C2M EYE-MASK FIGURE 120E-13 UPDATE PROPOSAL

IEEE 802.bs Adhoc Meeting

October 10, 2016

Figure 120E-13—PAM4 eye measurements

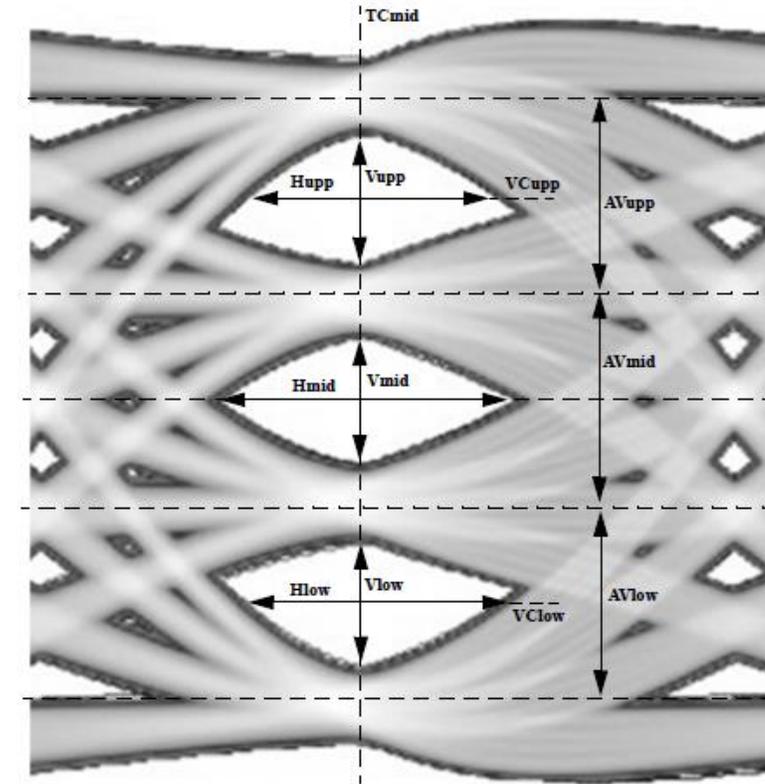
“Section 120E.4.2 Eye Width and Eye Height Measurement Method” includes terminology that it is not reflected in the corresponding Figure 120E-13 and vice versa.

1. +1/3 (MIDCDF1) and -1/3 MIDCDF0 are mentioned in text but there is no reference in corresponding figure.
2. MIDCDF0, MIDCDF1, LOWCDF0, LOWCDF1, UPPCDF0, UPPCDF1 are mentioned in text but there is no reference in corresponding figure.
3. VCmid is mentioned in text but there is no reference in corresponding figure.
4. MIDCDFL, MIDCDRL are mentioned in text but there is no reference in corresponding figure.
5. Since VEC equation was deleted per comment #173 against draft Rev 2.0, remove from subject figure the references Avupp, Avmid, Avlow.

Proposed Edits to Figure 120E-13

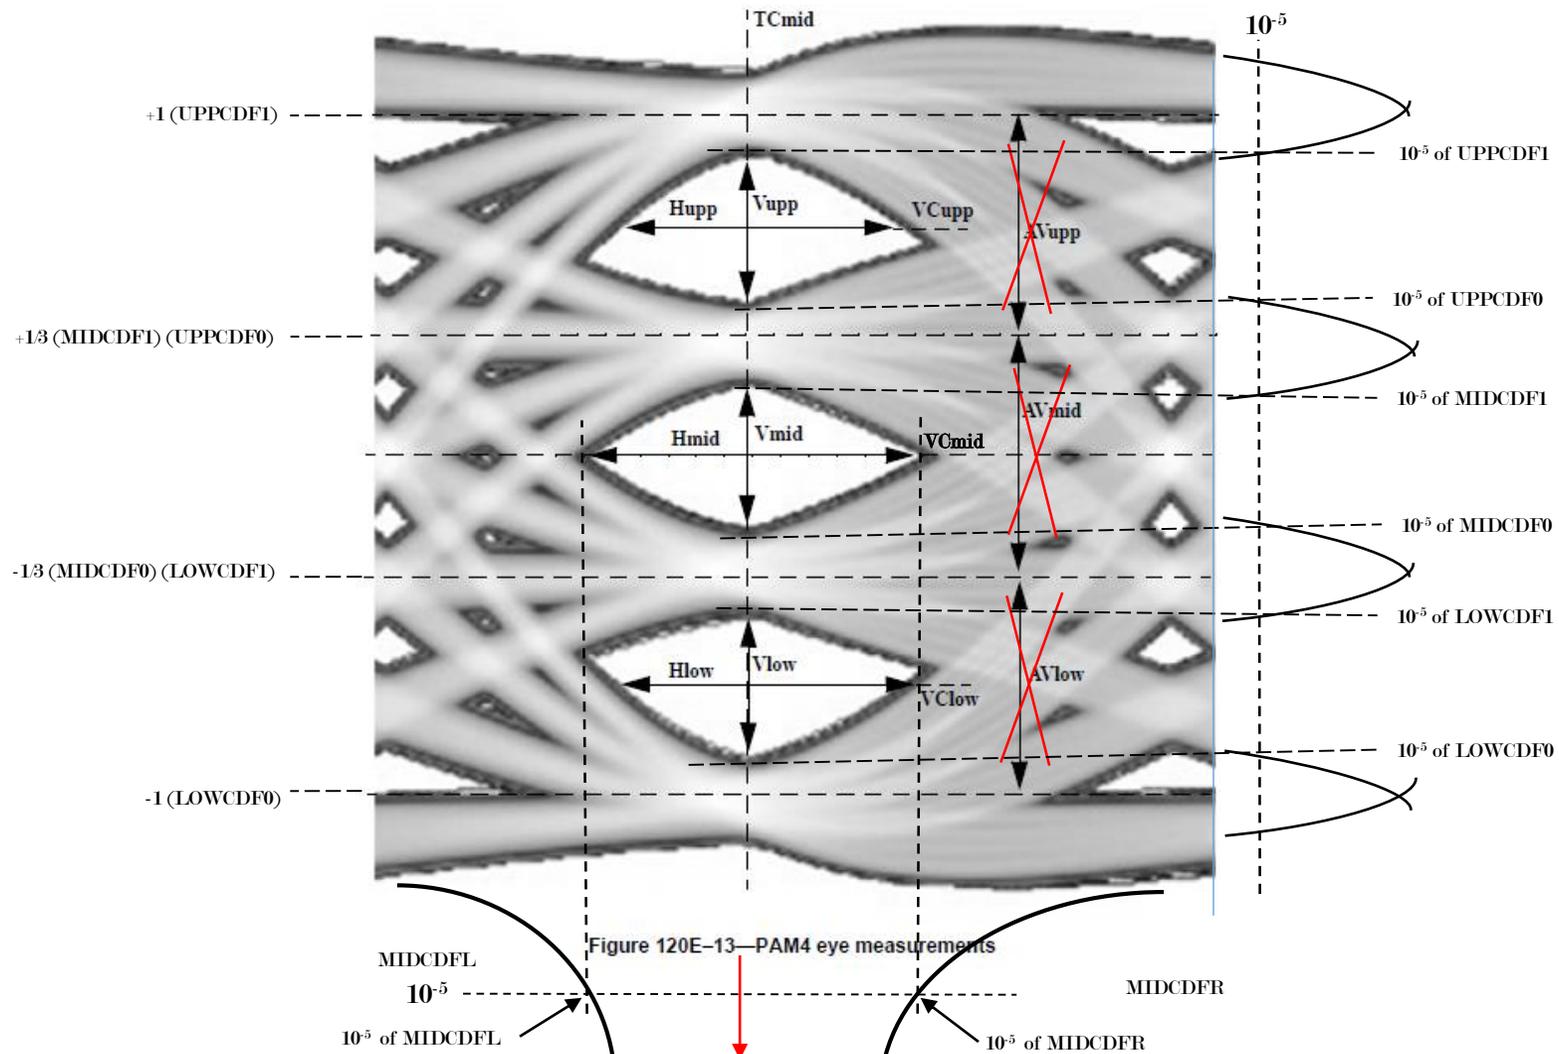
1. MIDCDF0, MIDCDF1, LOWCDF0, LOWCDF1, UPPCDF0, UPPCDF1 are mentioned in text but there is no reference in corresponding figure.

2. VCmid is mentioned in text but there is no reference in corresponding figure.

3. MIDCDFL, MIDCDFR are mentioned in text but there is no reference in corresponding figure.

4. Since VEC equation was deleted per comment #173 against draft Rev 2.0, remove from subject figure the references Avupp, Avmid, Avlow.

Solution: Add MIDCDF0, MIDCDF1, LOWCDF0, LOWCDF1, UPPCDF0, UPPCDF1 to Figure 120E-13

Solution: Add VCmid to Figure 120E-13

Solution: MIDCDFL, MIDCDFR to Figure 120E-13

* Note to Editor: Move title down
